Re: Request for U.S. EPA Approval
Work Plan for Post-Removal Sampling and UST Removal – Revision 2
Former Delphi Harrison Thermal Systems Facility
U.S. EPA ID No. OHD 017 958 604

TO U.S. EPA'S MARCH 5, 2009
COMMENTS OF TECHNICAL REVIEW
ON THE FEBRUARY 12, 2009 DOCUMENT ENTITLED
"REQUEST FOR EPA APPROVAL OF THE
REVISED WORK PLAN FOR POST-REMOVAL SAMPLING
AND UST REMOVAL"

GENERAL MOTORS CORPORATION
FORMER DELPHI HARRISON THERMAL SYSTEMS FACILITY
DAYTON, OHIO

figure 3
 UST 3 LOCATION
 FORMER DELPHI HARRISON
 THERMAL SYSTEMS FACILITY
 Dayton, Ohio

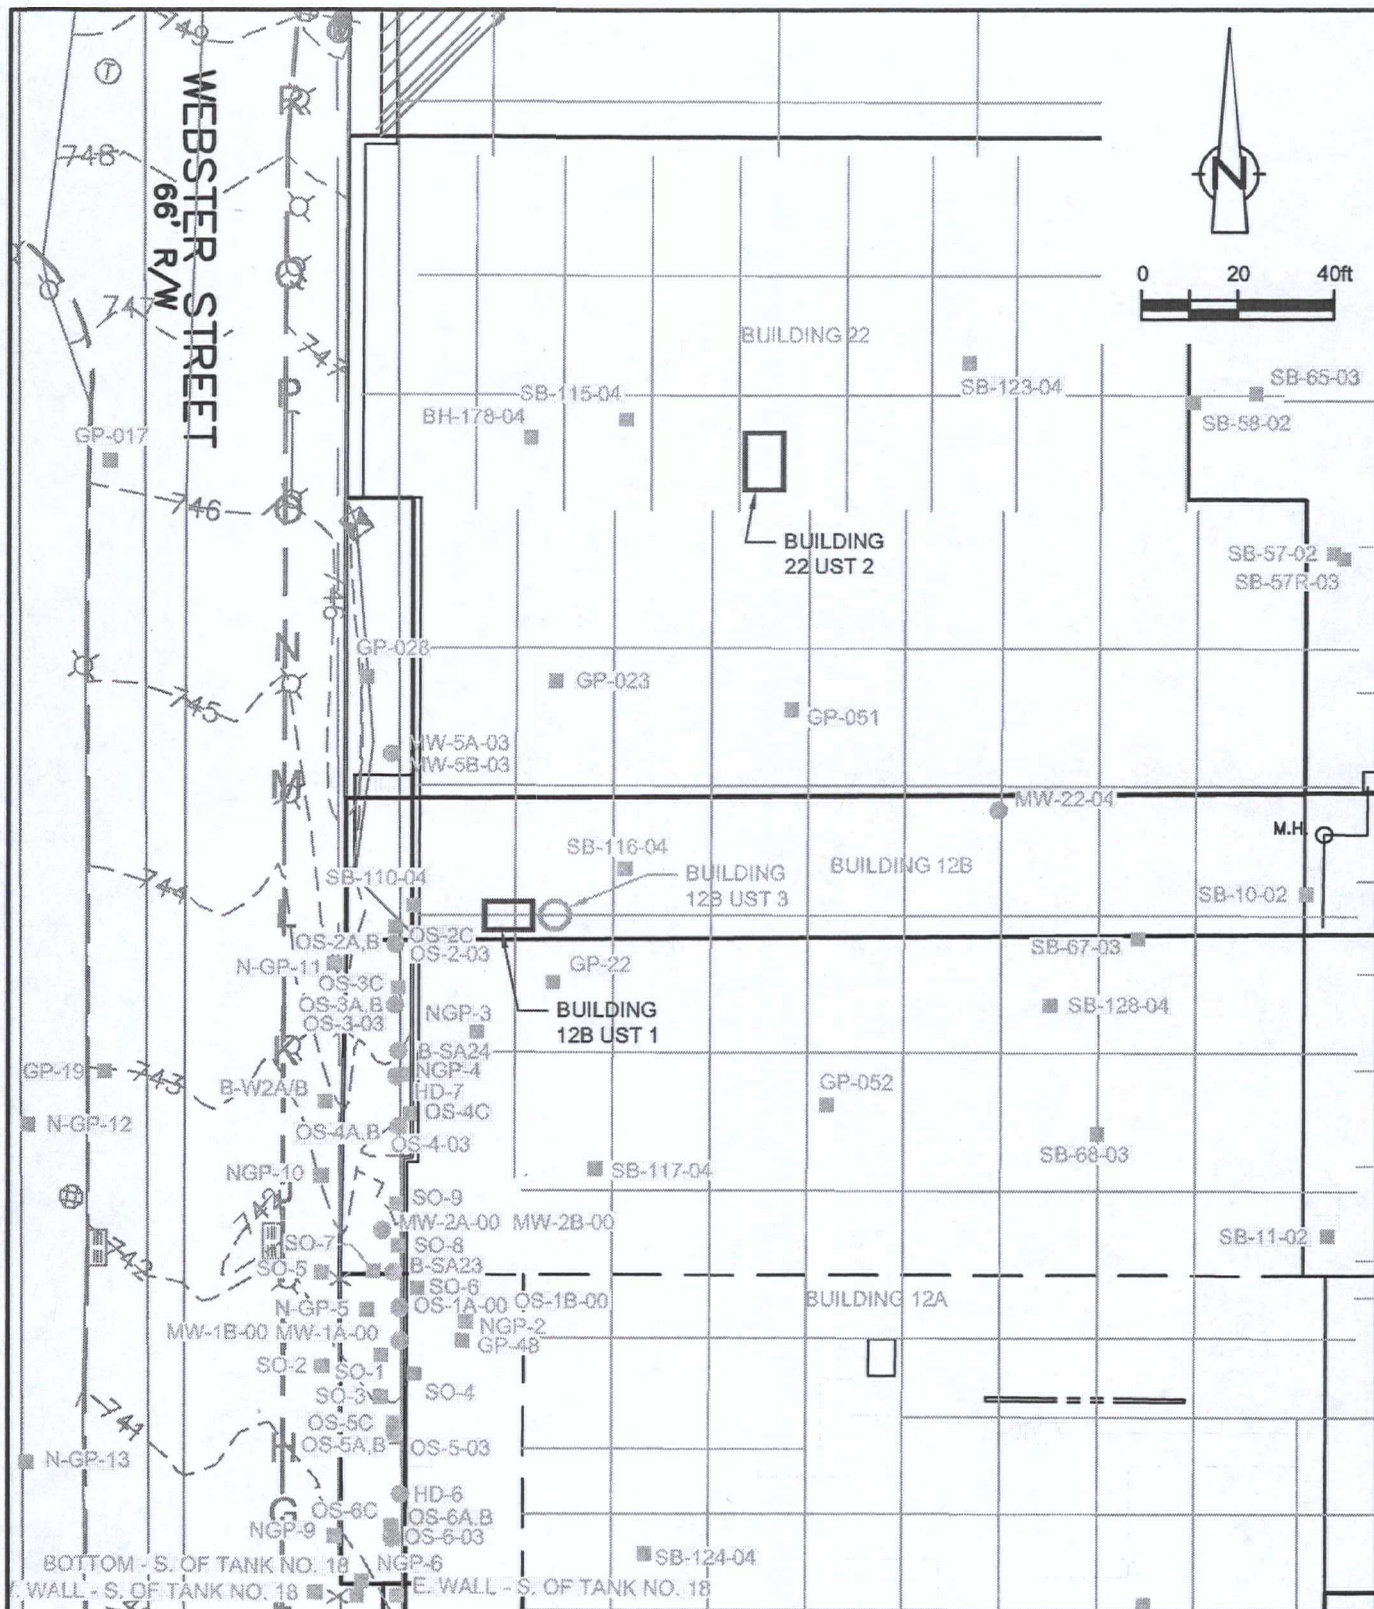
Adequacy of Response/Remaining Issues: Although Booz Allen has not had the opportunity to review the Work Plan dated November 3, 2006 for removal of UST 3, GM's proposal to conduct the action in a similar manner to that performed for UST 1 (AOI 42) is conceptually acceptable (RFI Addendum 1, Section 2.13.3). However, three specific issues must be addressed by GM during removal of UST 3:

- As GM indicates, the highest post-removal PCB detection at AOI 42 was identified on the eastern sidewall of the excavation, within approximately two feet of the Building 12B UST 3 footprint. Due to the close proximity between the tanks, GM should consider removal of previously identified PCB-impacted soil around AOI 42 sampling location S-011 as part of the tank removal effort. GM should also conduct additional vertical delineation sampling at depth intervals greater than 6 feet bgs (similar to that proposed for borings in the Work Plan for Additional Delineation Sampling) to obtain greater information on the vertical extent of PCBs observed at location S-011 in August 2006.

- GM should ensure that water from the UST still in place at AOI 48 (Building 12B UST 3) is properly managed, treated, and disposed. This water appears to be regulated under both TSCA and RCRA, based on measured concentrations of PCBs and vinyl chloride in the City's water sample collected on August 29, 2006. Dilution is an impermissible activity under both regulatory programs and will not be acceptable as a means for managing PCB-containing water in the tank.

- GM should provide additional detail as to whether the concrete block wall will also be removed as part of the tank removal effort. To ensure compliance with TSCA, support ongoing risk assessment efforts, and guide corrective measures at the Site, the "as-found" concentration of PCBs in that concrete wall should be determined prior to removal, or during confirmation sampling if the wall is to remain in place. GM should ensure that characterization and confirmation sampling in this location is conducted in accordance with relevant guidance in 40 CFR Part 761, Subparts N and O, respectively.

GM Response: *An updated Work Plan for removal of UST 3 is presented in this document. This work plan has been revised to specify that the western sidewall sample will be collected from a depth greater than S-011 and to specify that foundation walls adjacent to the UST will be sampled. Given that the PCB concentration in sample S-011 is within the range of PCB concentrations in soil between Webster and Taylor Streets (non-detect to 272 mg/kg at SB-109-04), for which a risk assessment has been conducted, GM will consider soil removal only*

if the concentration of PCBs in the soil samples to be collected are higher than those already evaluated in the risk assessment. The work plan already specifies that water would be containerized, sampled for waste characterization, and disposed of off-site in accordance with applicable regulations. Given that water in the UST is believed to be perched runoff and the City's sample was collected over 2 years ago, GM believes that characterization of the water at the time of UST removal is more appropriate for waste disposal.
